***PEER REVIEW:***

***SALTWATER INTRUSION AND THE  
MINIMUM AQUIFER LEVEL IN THE  
SOUTHERN WATER USE CAUTION  
AREA: Hydrologic Evaluation Section,  
Southwest Florida Water Management  
District, 21 August 2002 (draft)***

***Gordon Bennett  
John Bredehoeft  
Louis H. Motz***

***September 2002***

Figure 1. Hydrograph of Sarasota Deep well. The solid black line is the 10-year moving average plotted for the last year averaged. (Figure 21—subject document)

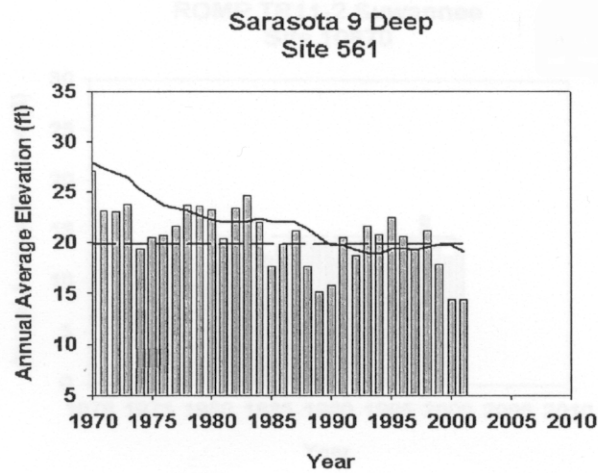
The period chosen for setting the minimum water level was chosen as 1999 and the preceding 9 years—1990-1998. The subject document shows that this is the highest 10-year average water level within the last several years. The hydrograph of the Sarasota 9 Deep Observation well, Figure 1, indicates that water levels were more or less stable during the decade of the 1990s. ***The period 1990 to 1999 seems like a good choice although we recognize that this period represents the highest average water level in recent years.***

Figure 2. Drawdown from predevelopment to 1999 in UFA. (Figure 12—Subject document).

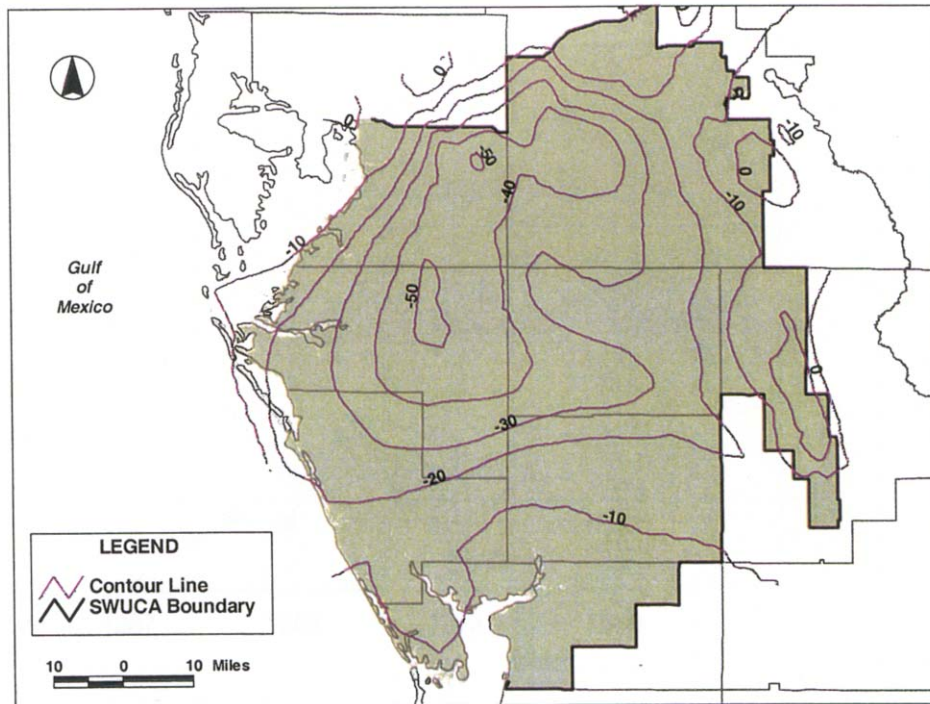
However, a large cone of depression occurs in the potentiometric surface of the Upper Floridan Aquifer at the boundary and to the east of the MIA. Figure 2 (Figure 12 from the subject document) shows the drawdown from predevelopment to 1999; the cone of depression is clear on this figure. Thus, part of a major pumping center apparently occurs landward (east) of the designated ETB MIA. Pumping from this area is reducing groundwater discharge in the coastal area and causing the interface to move farther inland. To control the rate of movement of the interface in the coastal ETB MIA area, it is important to control pumping in the area east of the MIA as well as in the MIA. Pumping throughout SWFWMD has an impact on the potentiometric surface and as a consequence the rate of movement of the interface. We suggest that the District investigate the pumping to the East to determine its impacts on water levels within the MIA; it may be necessary to control this pumping to effectively control water levels within the MIA.
